Subject: Notice of Violation No. R9-2014-0154, Mission Gorge Apartments Construction Project, Order No. 2009-0009-DWQ, NPDES Permit No. CAS000002, Construction General Permit

NOTICE OF VIOLATION
No. R9-2014-0154

FACILITY INSPECTION REPORT

FACILITY: Mission Gorge Apartments
WDID/FILE NO.: 937C369143

Photo 1

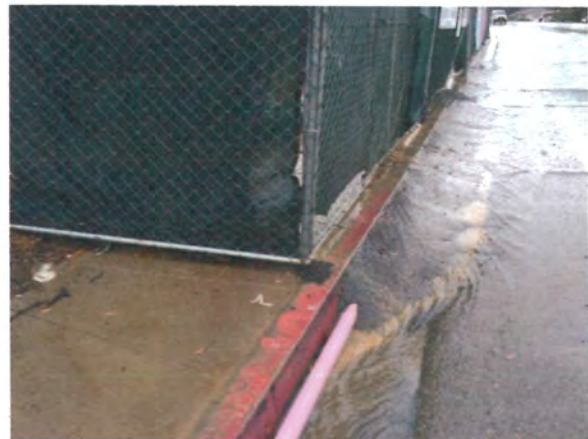
During a December 12, 2014 storm event, Ms. Ghoram observed a discharge of sediment-laden storm water from the site to the City of San Diego municipal separate storm sewer system (MS4) on Mission Gorge Road (See Photos 1 and 2). Wayne Chiu of the San Diego Water Board performed a follow up inspection of the Mission Gorge Apartments construction site for compliance with the requirements CGP to determine whether the discharge of sediment-laden storm water from the site was an authorized.. According to the Storm Water Multiple Application & Report Tracking System (SMARTS), the site is a Risk Level 1 construction site, disturbing over 10 acres, and owned being developed by KNR Mission Gorge LLC.

Photos 1 and 2 show discharges of sediment-laden storm water runoff from the site to the City of San Diego MS4 drainage system on Mission Gorge Road.

Photo 14

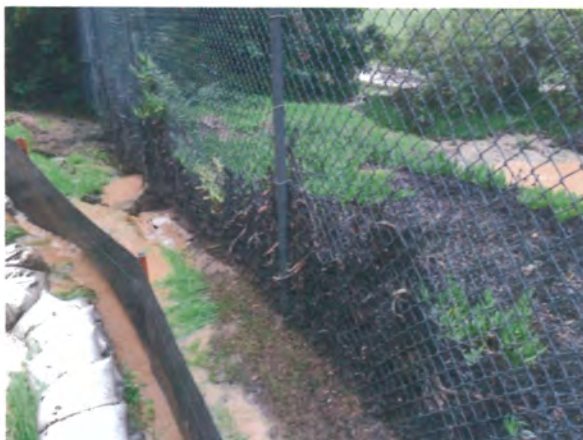
4. Lack of effective perimeter sediment controls observed which resulted in unauthorized sediment discharges from the site (See Photos 14 and 15). All construction sites are required to establish and maintain effective perimeter controls and stabilize all construction entrances and exits to sufficiently control erosion and sediment discharges from the site.

Photos 11 through 15 show pathway to unauthorized discharges of sediment and sediment-laden storm water runoff from the site to the San Diego River. Photo 11 shows area where runoff in Photos 5 through 8 collect. Photo 12 shows where runoff from Photo 11 flow down slope. Photo 13 shows where flow from Photo 12 emerges. Photo 14 shows where flow from Photo 13 and Photos 9 and 10 converge and discharge from location in perimeter controls (i.e. gravel bags) that appears to have been moved to allow flow off site. Photo 15 shows sediment-laden storm water runoff flowing off site to the San Diego River due to inadequate implementation of erosion controls, runoff controls within the site, and perimeter sediment controls.
